CONTRACT NO. DE-AC27-01RV14136 – THE U.S. DEPARTMENT OF ENERGY, WASTE TREATMENT AND IMMOBILIZATION PLANT (DOE-WTP) SURVEILLANCE REPORT S-11-WED-RPPWTP-042; REVIEW OF PRETREATMENT FACILITY (PTF) VESSEL VENT PROCESS (PVP) SYSTEM HEADER PIPE INSTALLATION IN PLANNING AREA 7

Review of Pretreatment Facility (PTF) Vessel Vent Process (PVP) System Header Pipe Installation in Planning Area 7

Report Number: S-11-WED-RPPWTP-042

Fig. 1, Model view showing installed section

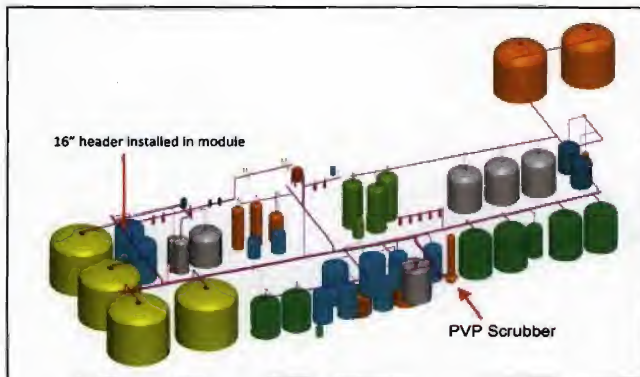
A large piping module was installed in the PTF Planning Area 7 in late July, including a section of 16" SC-I, Safety Class PTF PVP system header piping (see Figures 1 & 2 below):

The PTF PVP system pipe in Planning Area 7, as installed, supports an active safety function of the system (either case 3 or 4 from CCN: 234433). The pipe is SC-I and Safety Class. Both of the scenarios cited in CCN: 234433 assume Multiple Sparger or Pulse Jet Mixer Overblow

Without MOB controls, the PTF PVP System would need to be sized to accommodate the flow associated with MOB conditions. This may require increasing the size of the PVP header enough to nearly double the airflow (from 4000 to 7000 scfm).

The first PVP system piping module was installed in Planning Area 7 in late July. The lack of MOB controls in the AB brings into question whether this pipe was undersized.
